**ADDENDUM
NO. 3**

**BOONE GROVE HIGH SCHOOL
RENOVATION AND RELATED WORK
Valparaiso, IN 46341**

ADDENDUM THREE

Addendum Three (AD.03) to the drawings and specifications prepared by Gibraltar Design for **Boone Grove HS Renovation and Related Work** for Porter Township School Corporation, Valparaiso, Indiana.

UNIT "E" ARCHITECTURAL FIRST FLOOR CEILING PLAN

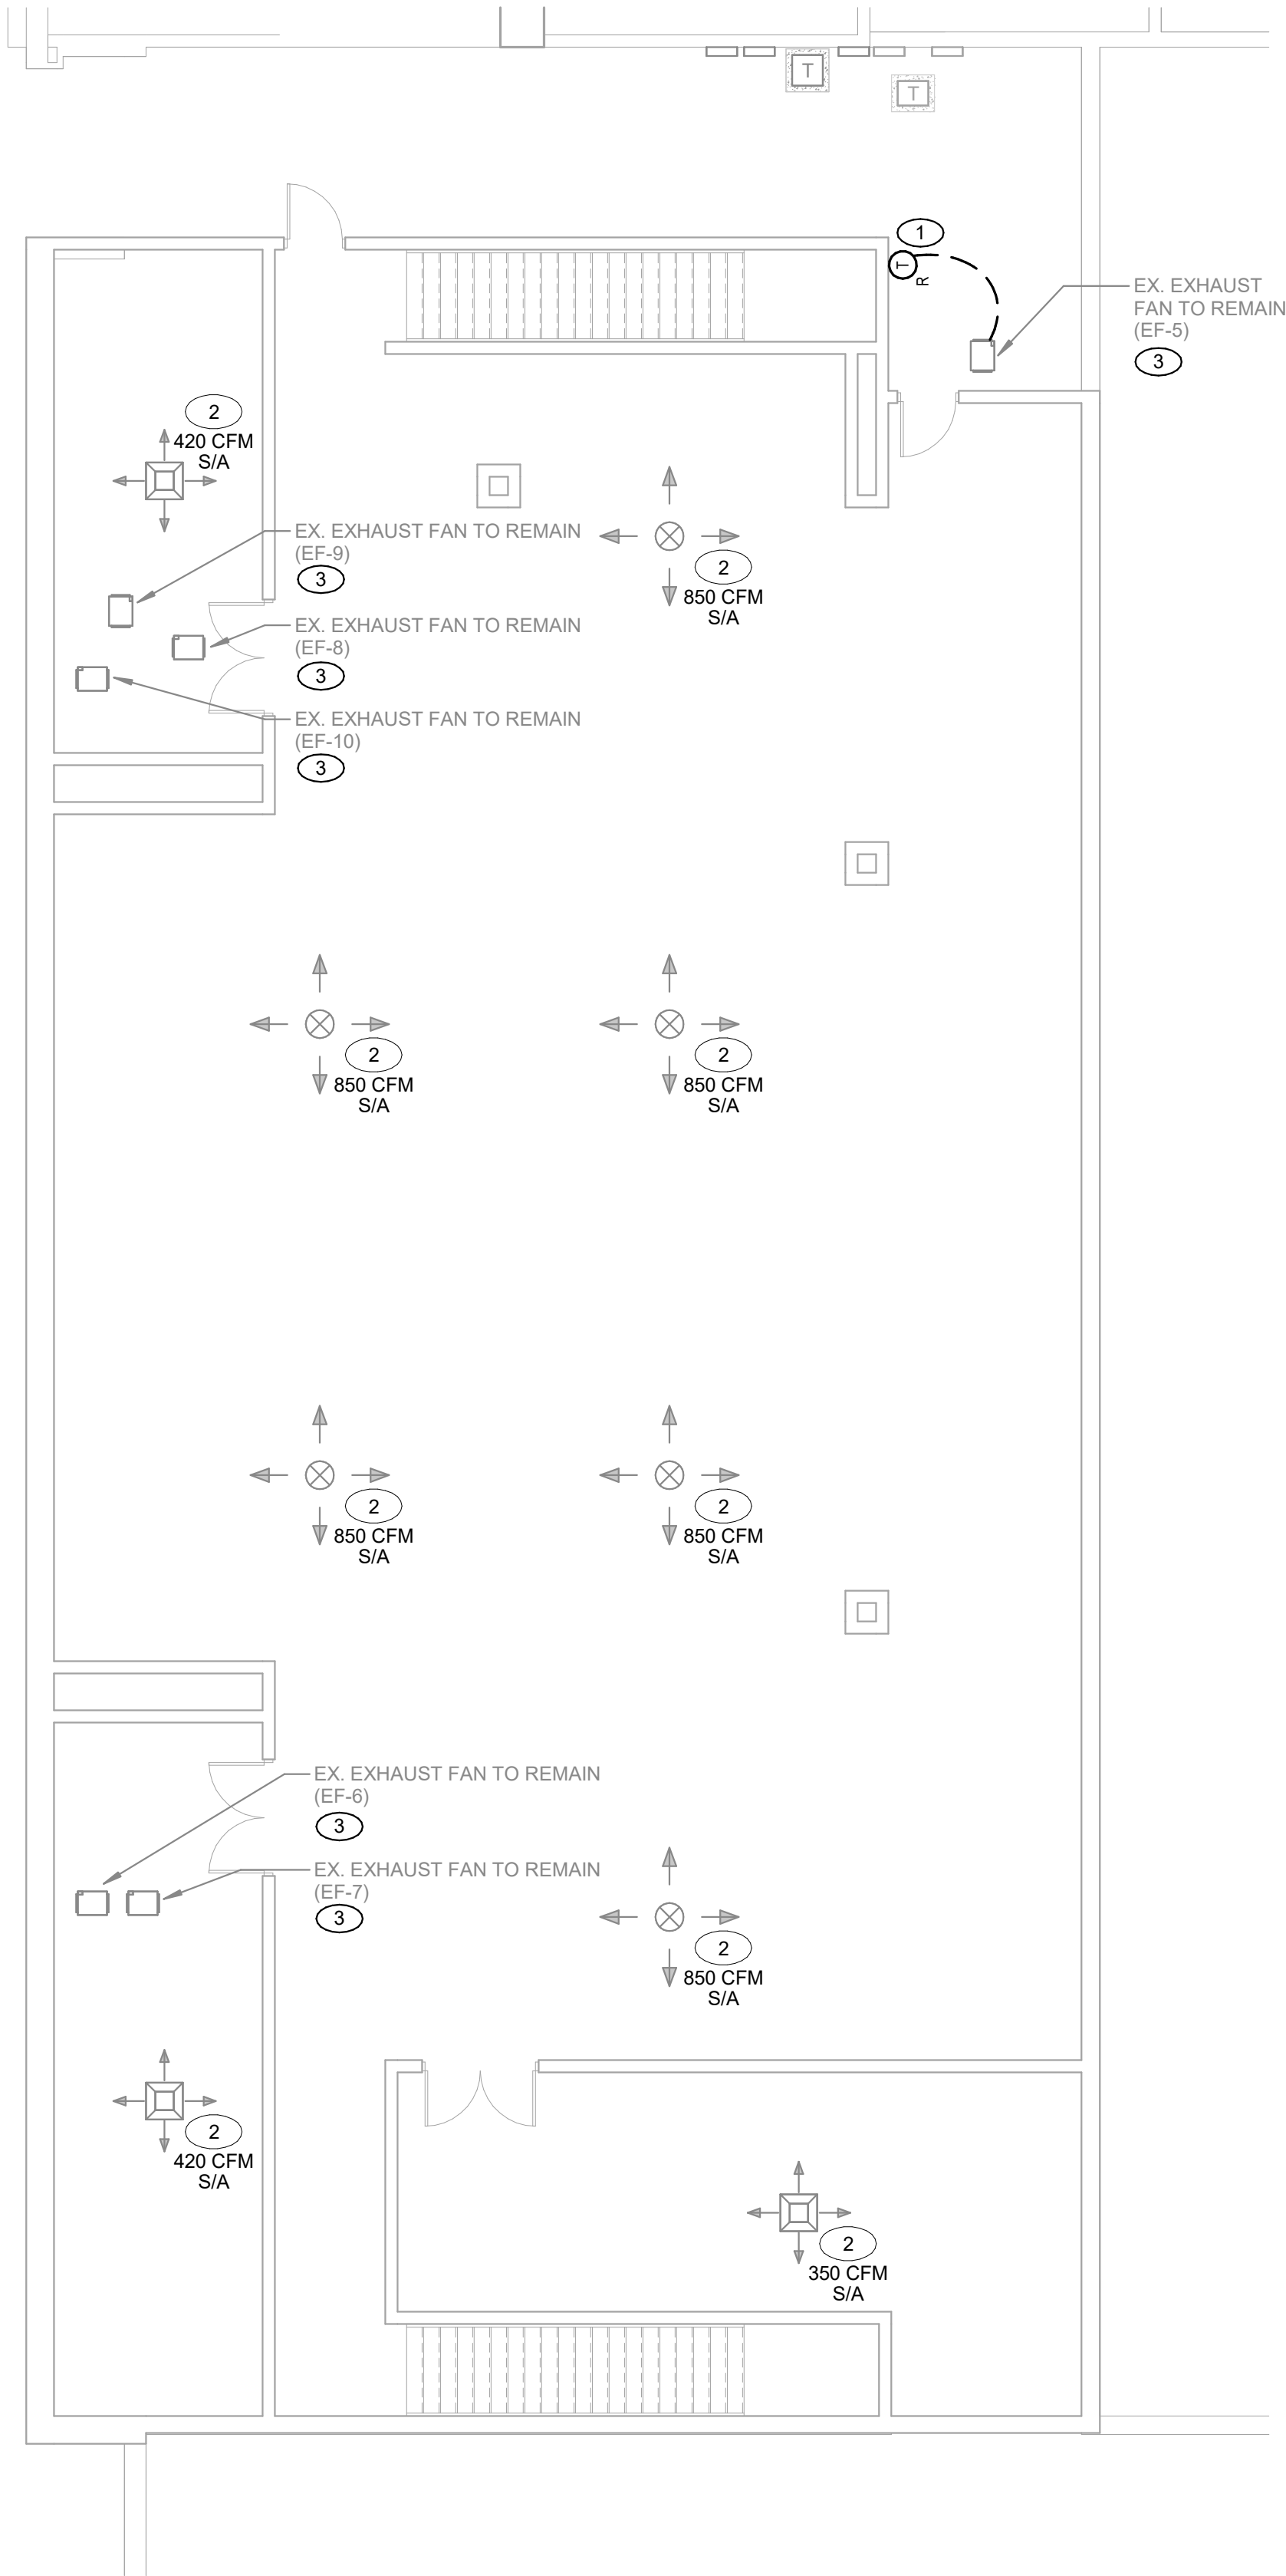
- A. Refer to revised, full-size drawing, included in this Addendum, for revisions.
 - 1. Above the indication CORRIDOR E102, added the indication for existing gypsum board and Keynote C02 at the intersection of corridors E102 and E128.
 - 2. Revision to REFLECTED CEILING PLAN KEYNOTES number C04 to read 'NOT USED'.
 - 3. Removed references of note C04 from the ceiling plans.
 - 4. Added note "K" to GENERAL NOTES that reads "REFER TO SPRINKLER SHEETS FOR EXTENT OF SPRINKLER WORK, INCLUDING SELECTED AREAS OF BRANCHLINE RELOCATION."

1
M-201
UNIT "A" MECHANICAL MEZZANINE PLAN
1/8" = 1'-0"

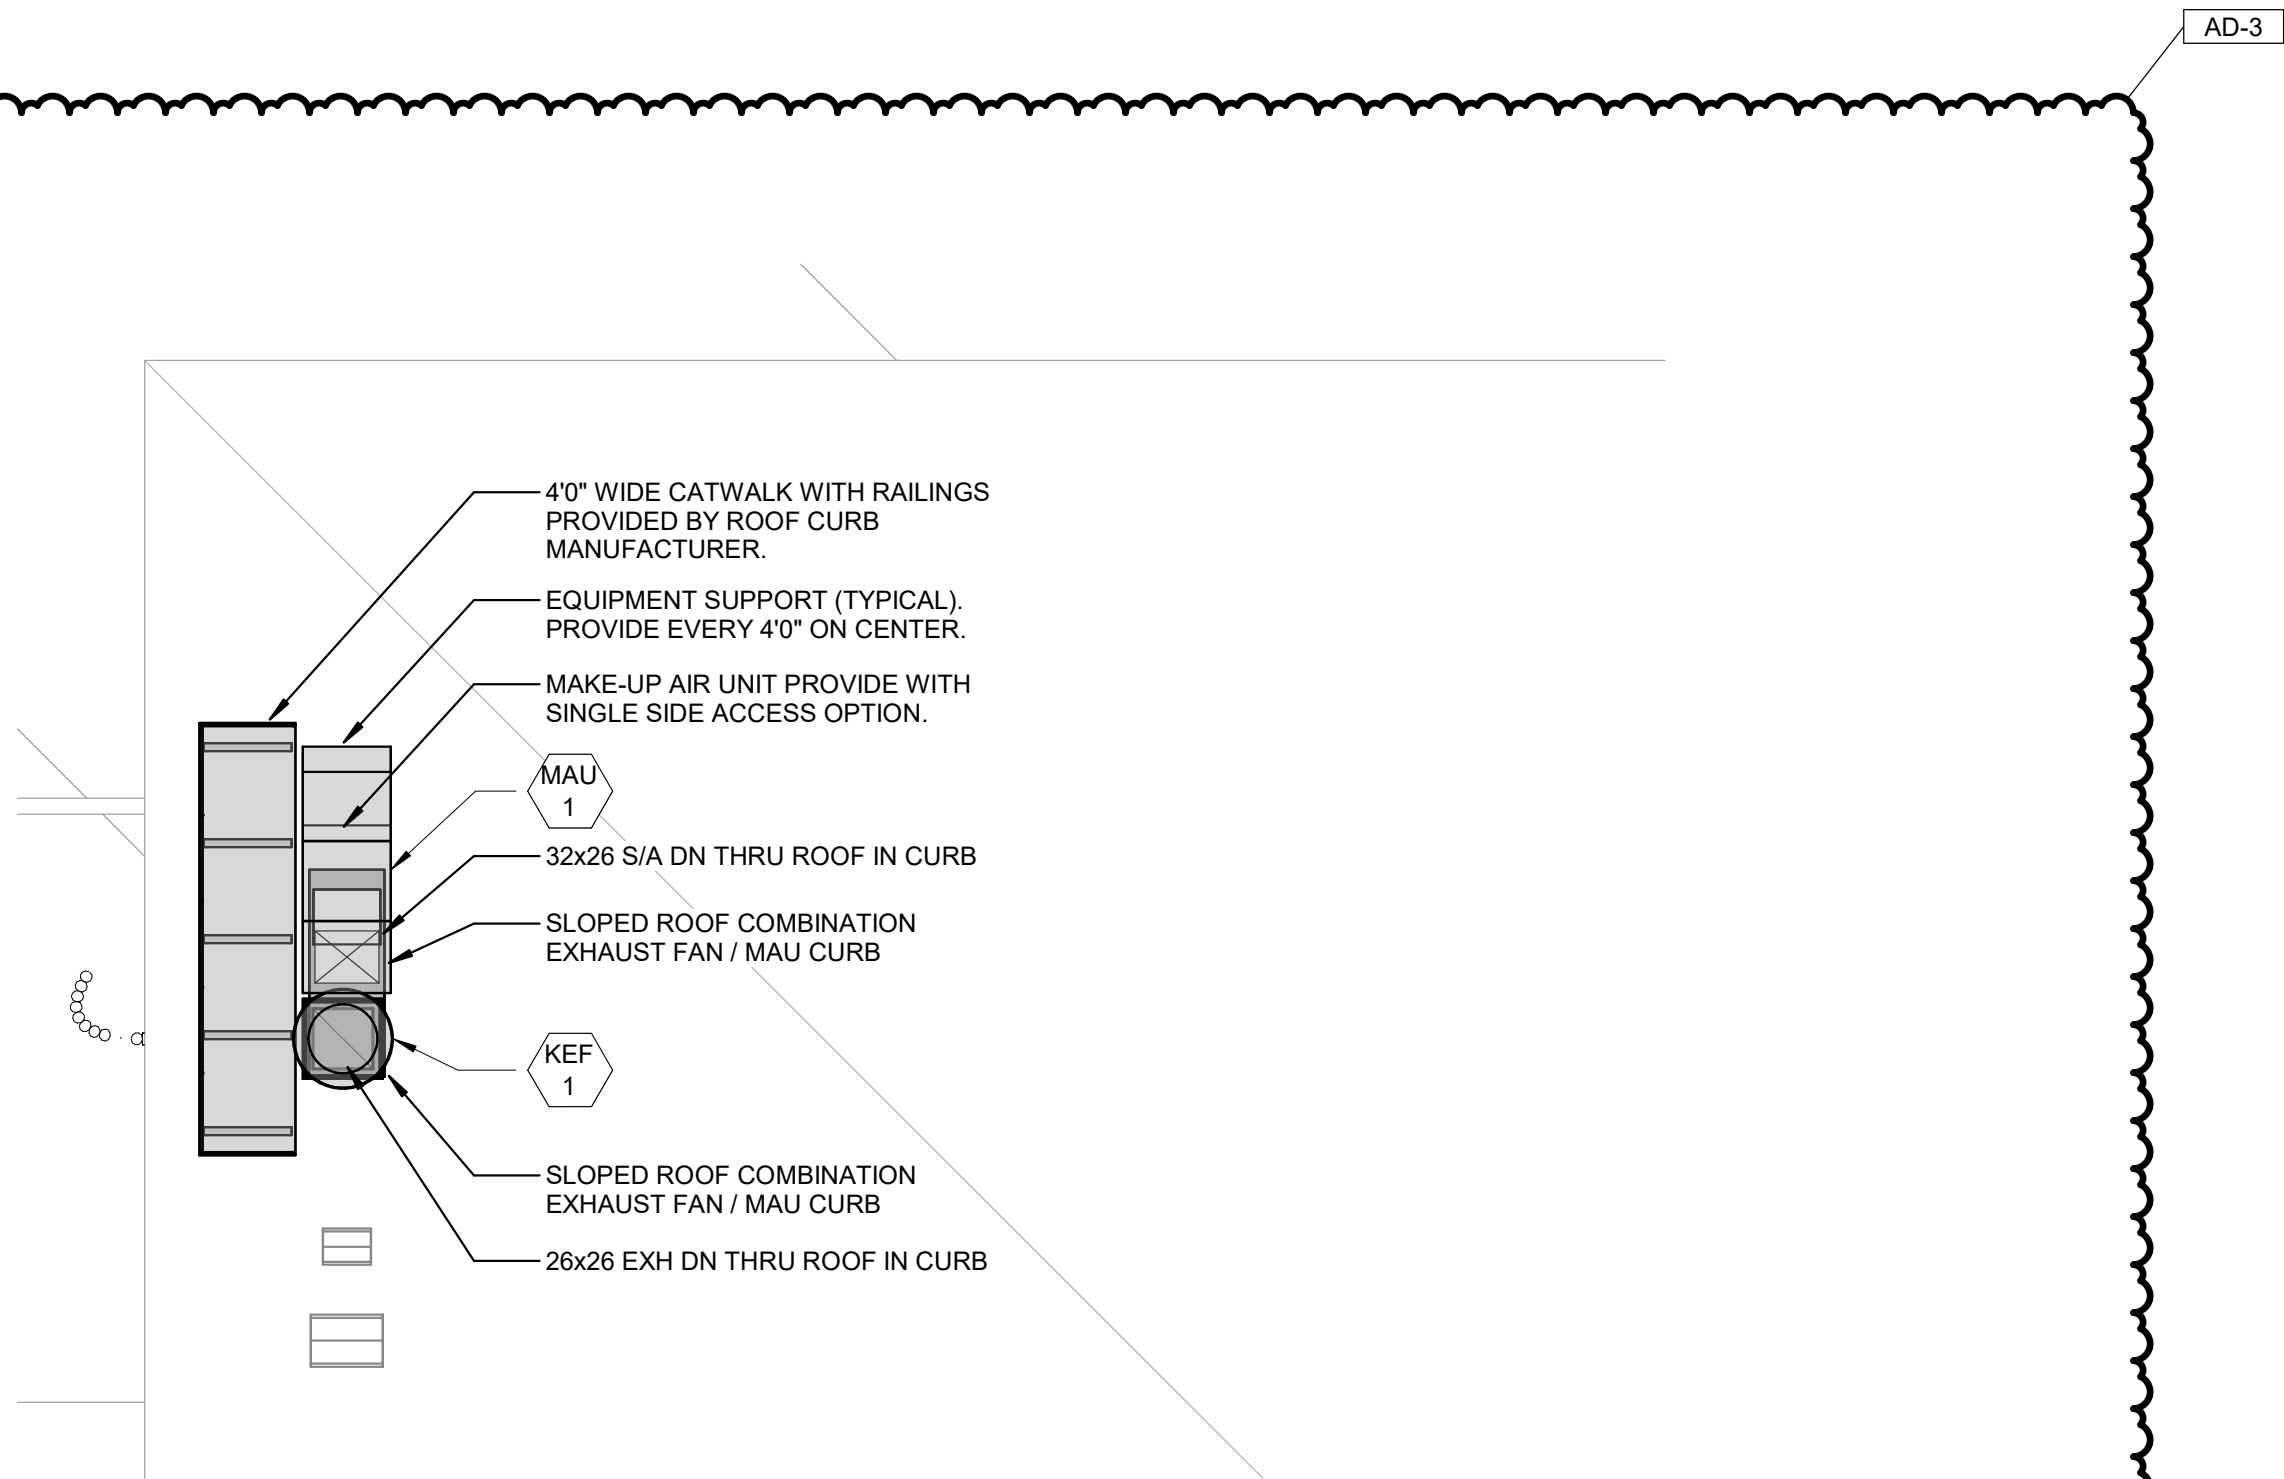
- A. Refer to revised, full-size drawing, included in this Addendum, for revisions.
 - 1. Added roof plan with make-up air unit and exhaust fan.

UNIT "A" ELECTRICAL FIRST
FLOOR DEMOLITION PLAN

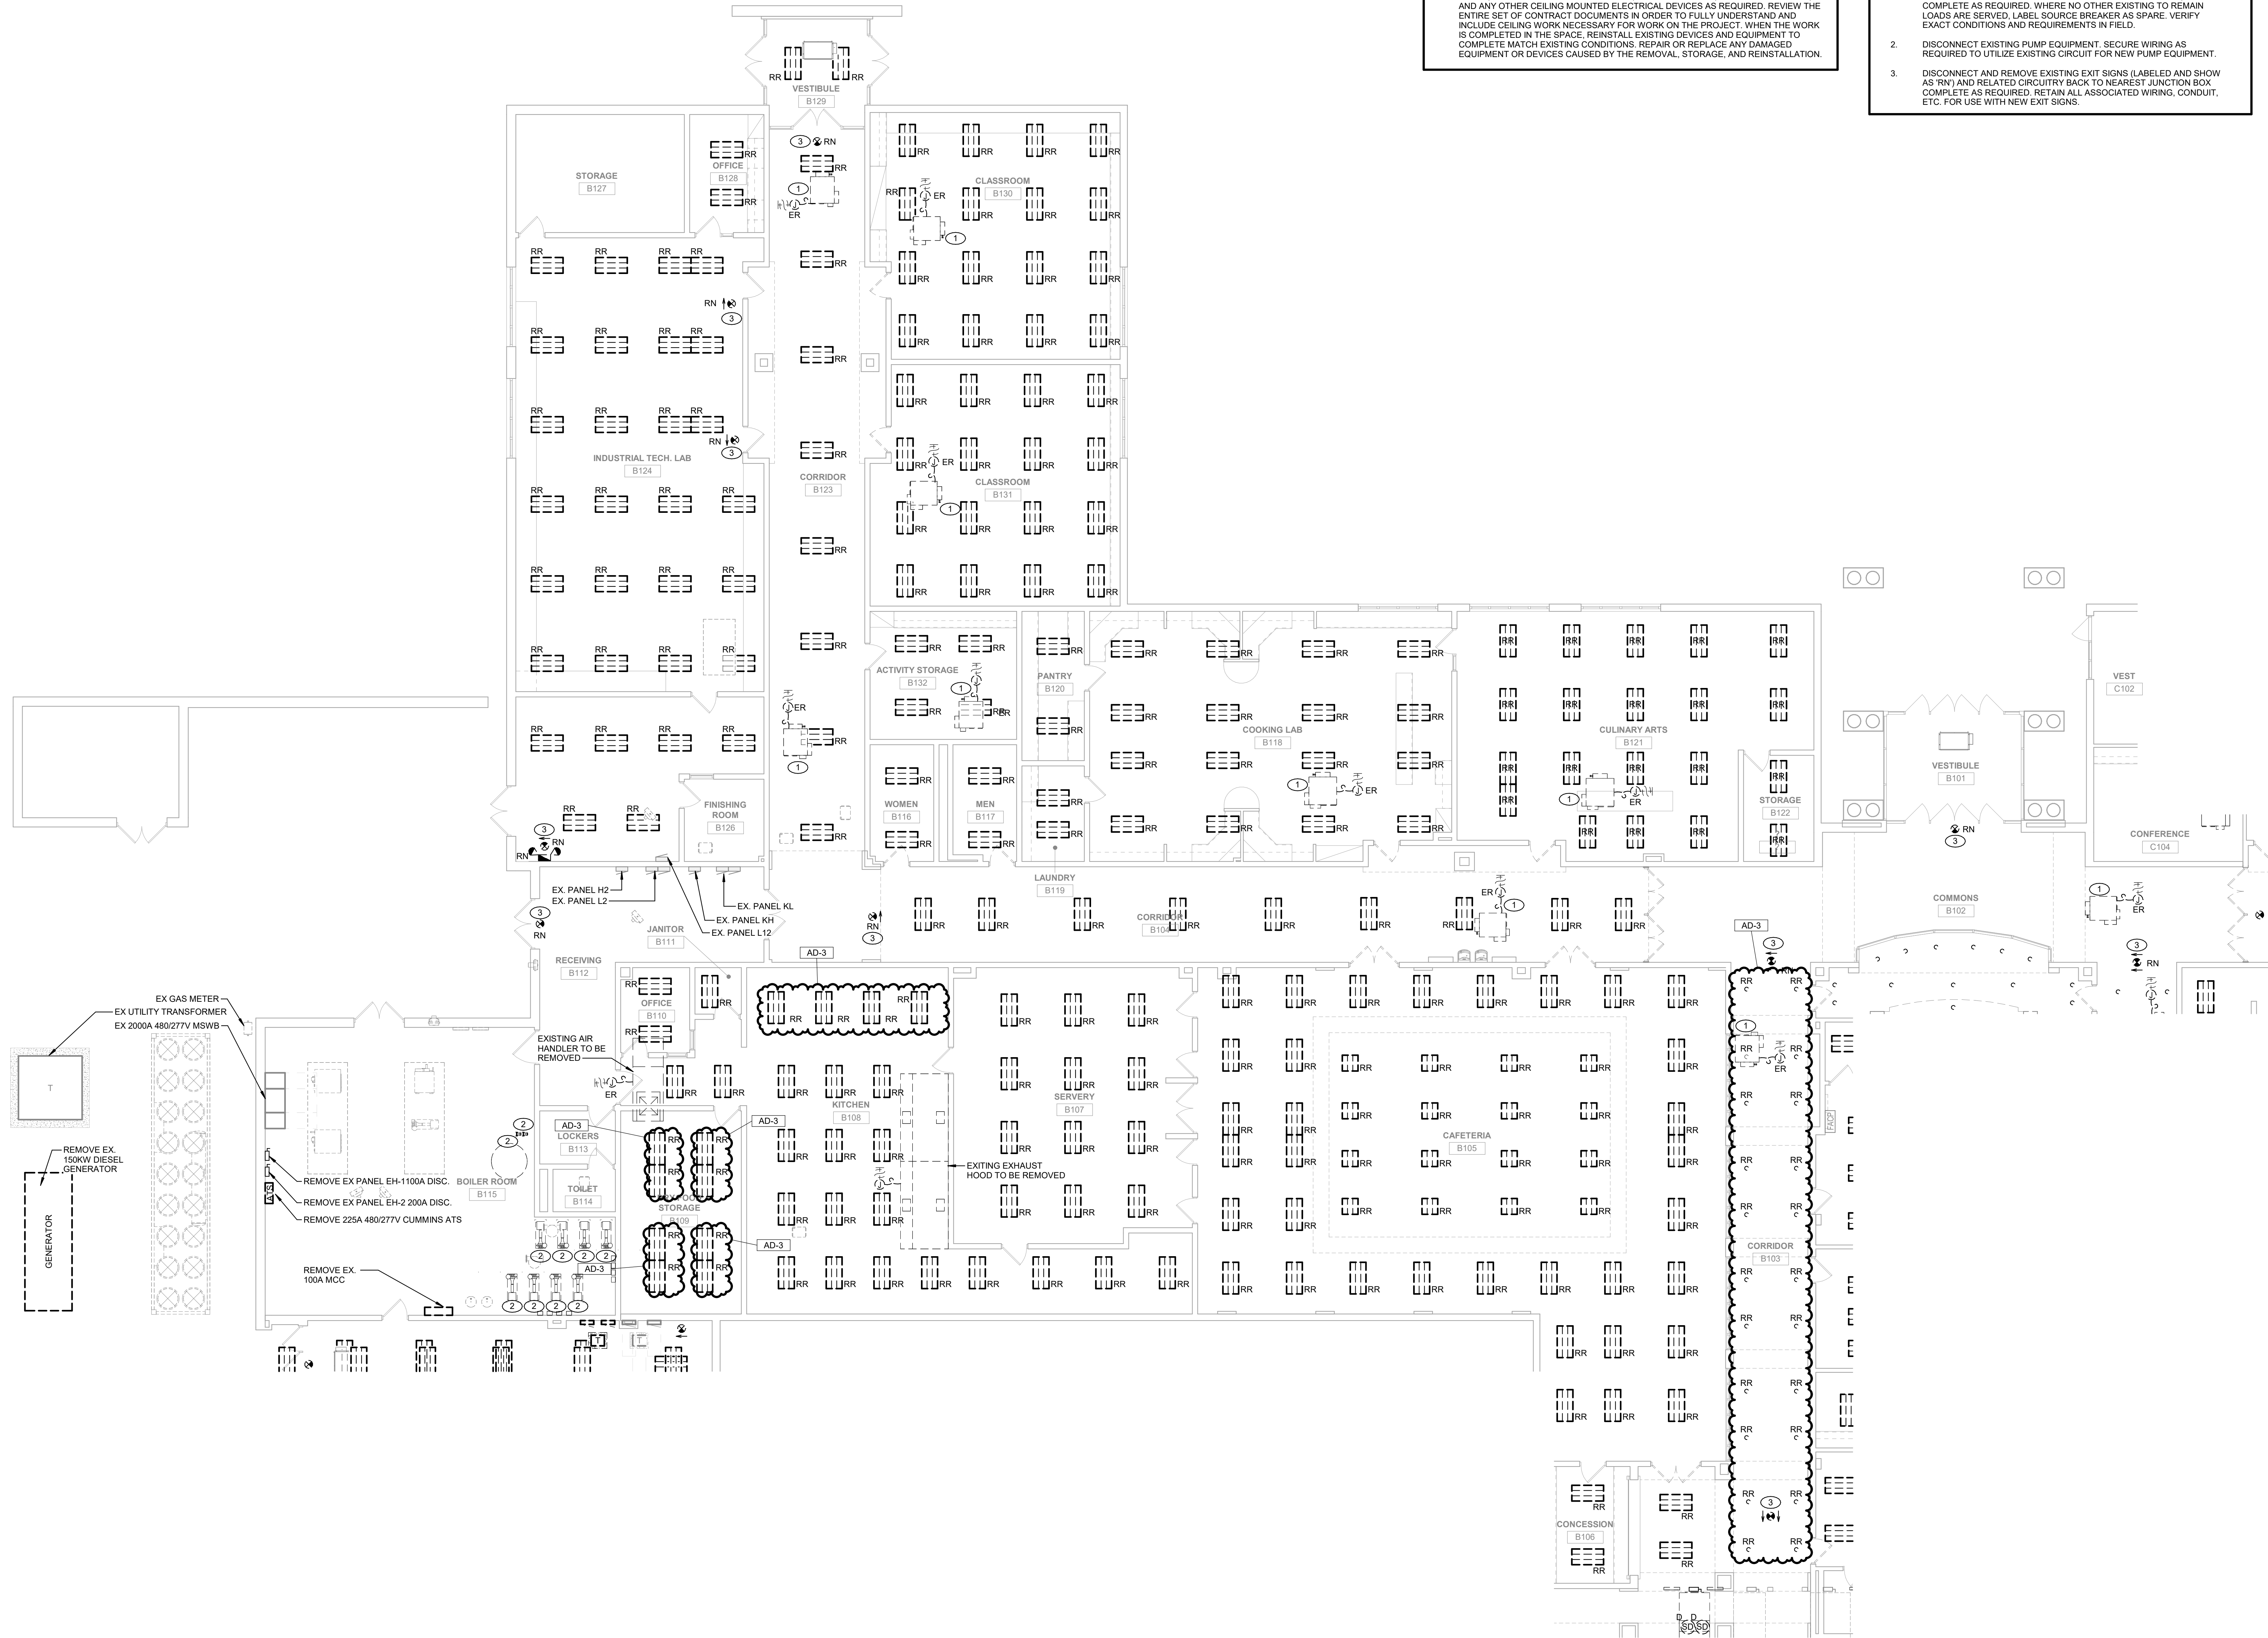
- A. Refer to revised, full-size drawing, included in this Addendum, for revisions.
 1. Added light fixtures to be removed and relocated.
